Technical Service BULLETIN

M.I.L. "ON" DTC P0031 AND/OR P2238

'04 RAV4

ENGINE
EG036-04

Figure 1. Location of Authorized Modifications Label on 2004 RAV4

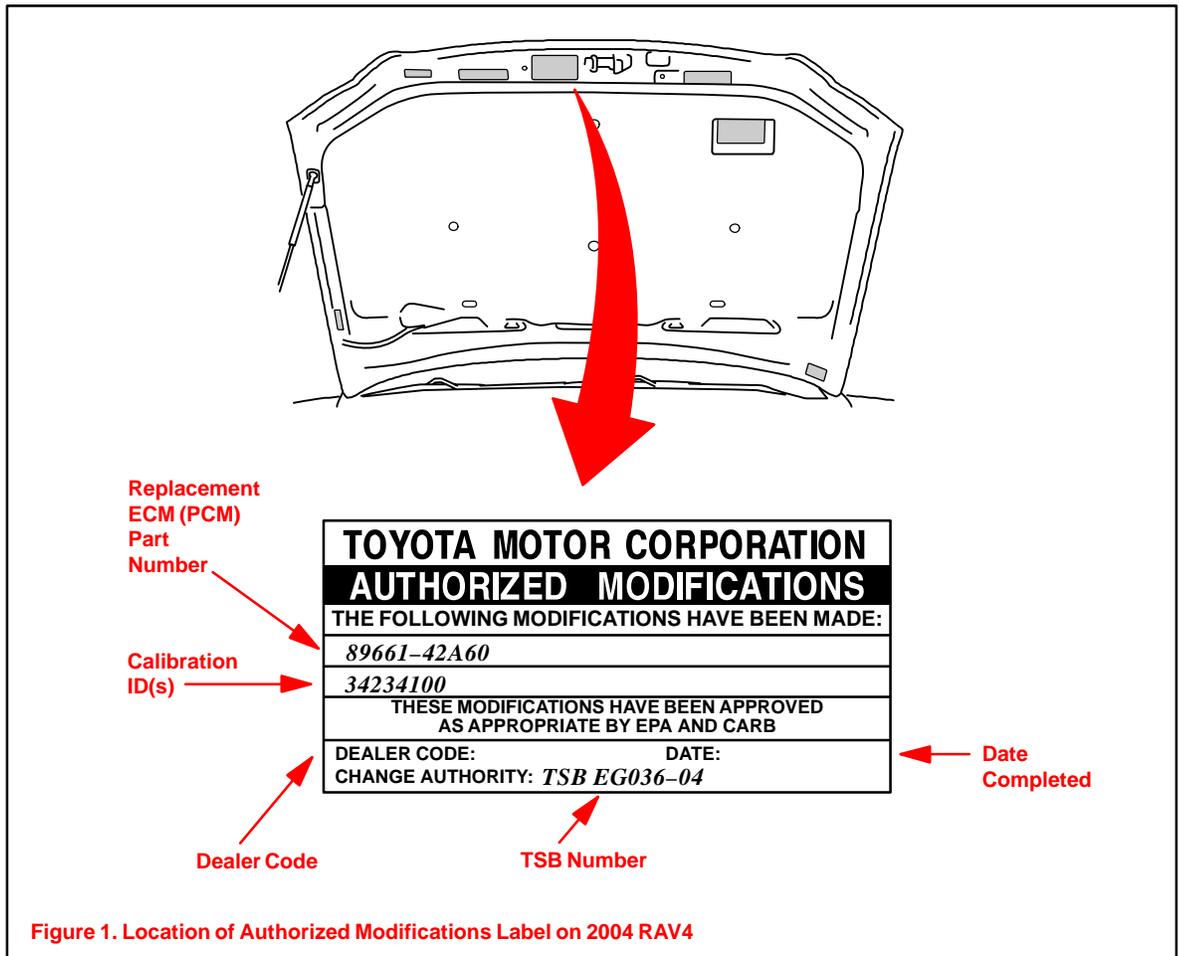
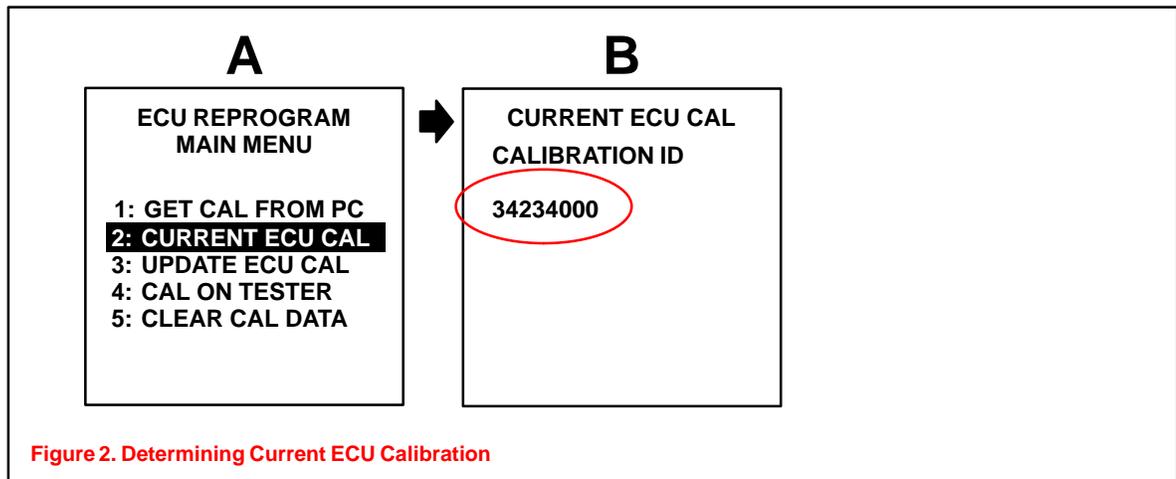
1. Check for the Authorized Modifications Label affixed to the vehicle in the location shown in Figure 1. Confirm if ECM (PCM) calibration has been updated. If not the latest ECM (PCM) calibration – **go to step 2.**

1. Follow the procedures outlined in TSB No. SS002–01, "ECU Flash Reprogramming Process," and flash the ECM (PCM) with new calibration file update.
2. Enter the required information on the Authorized Modifications Label and affix it to the vehicle at the location shown in Figure 1 (page 3). The Authorized Modifications Label is available through the MDC, P/N 00451–00001–LBL.
3. Calibration update is complete.
